**HARTZELL PROPELLER INC.**  
**SERVICE BULLETIN**  
**TRANSMITTAL SHEET**  
**HC-SB-61-379**  
**Propeller - Counterweight Clamp Inspection**

November 28, 2017

This page transmits a revision to Service Bulletin HC-SB-61-379.

- Original Issue, dated Oct 02/17
- Revision 1, dated Nov 28/17

**Inspection Areas**  
**Figure 1**

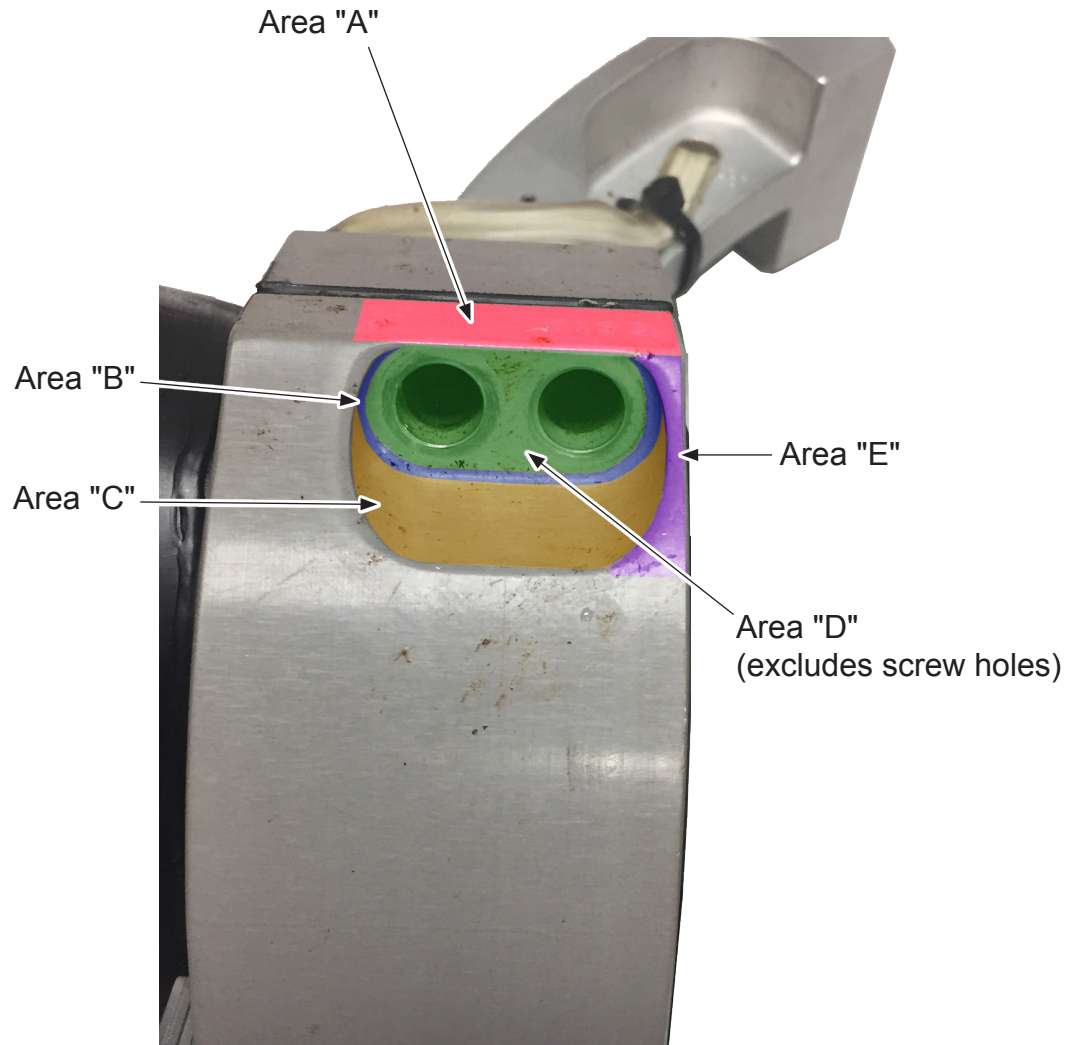
- (a) Visually examine Areas A, B, C, D, and E of the counterweight clamps for cracks. Refer to Figure 1 for inspection areas and Figure 2 for an example of a cracked counterweight clamp.

- NOTE: Counterweight clamp/mounting hardware installation must be performed by a certified propeller repair station with the appropriate rating.
- (c) Visually examine Area C and Area E of the counterweight clamp (refer to Figure 1) for damage to the anodize coating that may have occurred during hardware installation.

- 1 Cracks have occurred in Area E on the counterweight clamp.
- 2 If a crack is found during the visual inspection, retire all five of the counterweight clamps in accordance with Hartzell Propeller Standard Practices Manual 202A (61-01-02).
  - a Replace all five of the counterweight clamps in accordance with the Accomplishment Instructions in this Service Bulletin before further flight.

- 1 If there is damage to the anodize coating, clean the damaged area using Stoddard solvent CM23 or equivalent, then apply Ardrox AV 30 to the damaged area in accordance with the manufacturer's instructions.

Counterweight Clamp/Screw Identification  
Figure 3

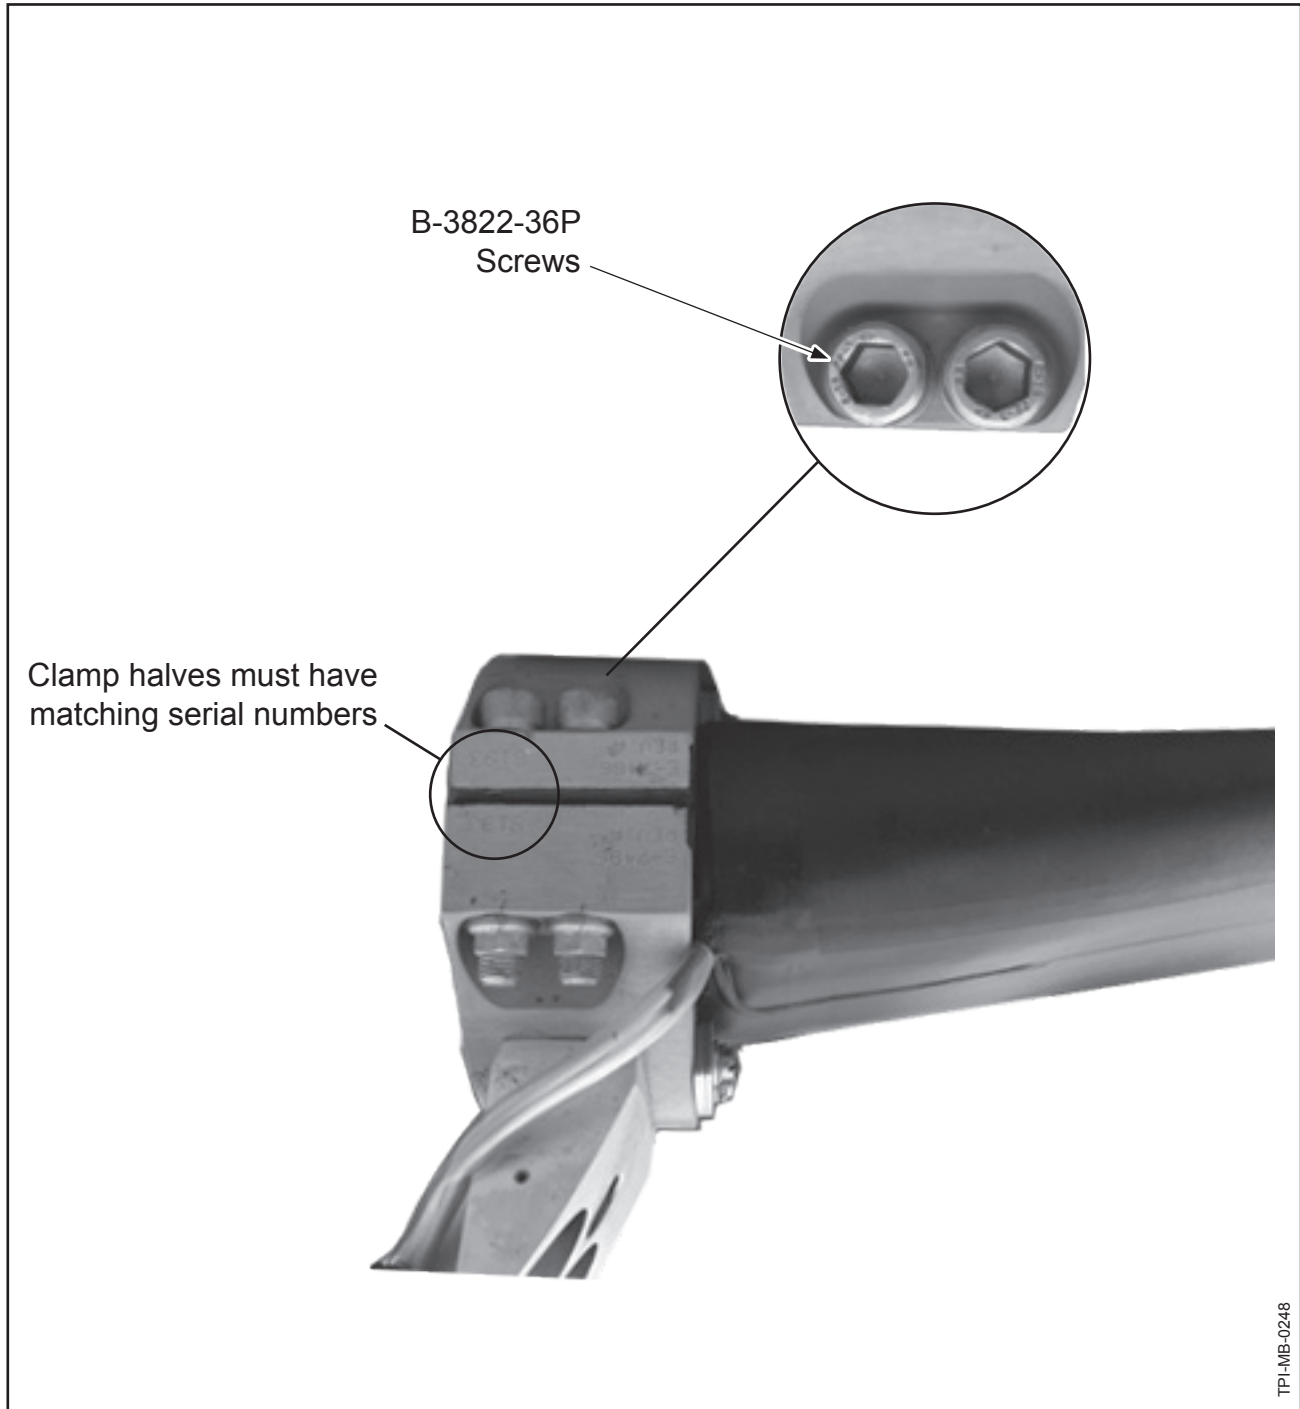
- (b) Visually examine the counterweight clamps and the associated hardware for the following:
- 1 Make sure that the counterweight clamps have matching serial numbers to indicate a matched set. Refer to Figure 3.

- 2 Check for loose or damaged counterweight clamp mounting hardware.
    - a Make sure that the correct counterweight clamp screws (B-3822-36P) are installed. Refer to Figure 3.

- a If required, install a new or serviceable counterweight clamp with matching serial numbers in accordance with the Accomplishment Instructions in this Service Bulletin before further flight.

- (1) Retire the counterweight clamp(s) with mismatched serial numbers in accordance with Hartzell Propeller Standard Practices Manual 202A (61-01-02).

**Counterweight Clamp Hardware Configuration**  
**Figure 4**

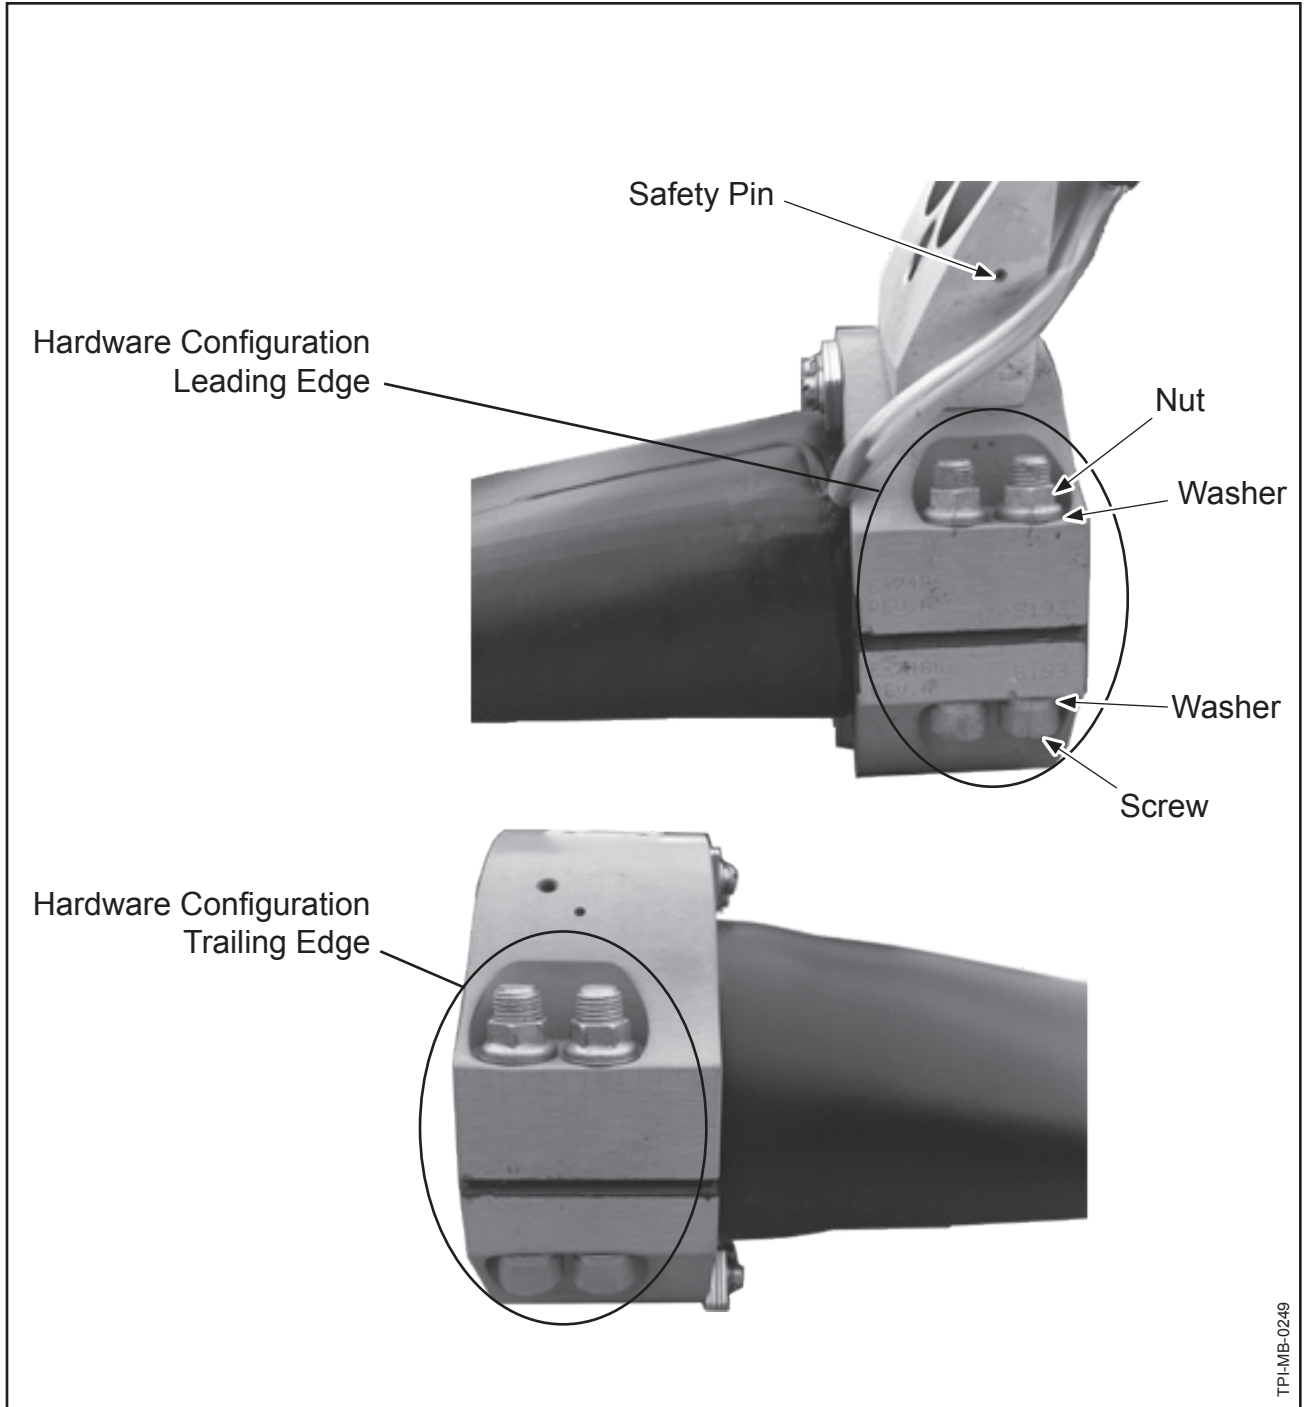
- b Make sure that the counterweight clamp hardware is installed in the correct orientation. Refer to Figure 4.
    - c Make sure that the safety pins in the counterweight attachment bolts are installed. Refer to Figure 4.

- d Replace any missing, damaged, or incorrect mounting hardware in accordance with Hartzell Propeller Inc. Composite Propeller Blade Maintenance Manual 135F (61-13-35) before further flight. Refer to the Material Information section in this Service Bulletin for part number information.
